- Subject** ▶ Changes on blade clamp, hex socket head bolt and leaf spring
- For Models** ▶ JR3020, JR3000V and JR3000 (Recipro Saws)
- Description** ▶ As described below, three parts have been changed for easier saw blade fixing.

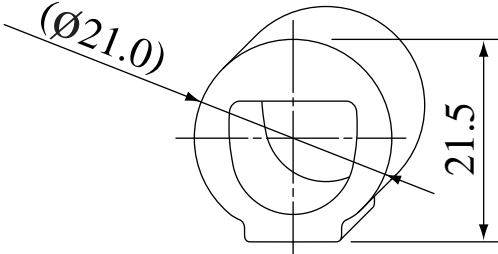
► Current	► New
Blade Clamp		
Hex Socket Head Bolt to fix blade clamp	 M5x13 1mm protrusion which prevents blade from falling out	 M5x15 Protrusion is prolonged to 2mm.
Leaf Spring (JR3020 only)		 Hole for the hex bolt's protrusion to go through

Item No.	Current part		Q'ty	I/C	New part		Q'ty	Note
10	Blade Clamp 313067-2		1	No	Blade Clamp 313075-3		1	Interchangeable as a set JR3020
11	Hex Socket Head Bolt M5X13 265986-7		1	No	Hex Socket Head Bolt M5X15 266090-5		1	
9	Leaf Spring 232129-6		1	<=	Leaf Spring 232165-2		1	
32	Blade Clamp 313067-2		1	No	Blade Clamp 313075-3		1	Interchangeable as a set JR3000V, JR3000
70	Hex Socket Head Bolt M5X13 265986-7		1	No	Hex Socket Head Bolt M5X15 266090-5		1

JR 3020 : From serial No 17196E  
JR 3000V : From serial No 1613031E  
JR 3000 : From serial No 265822E
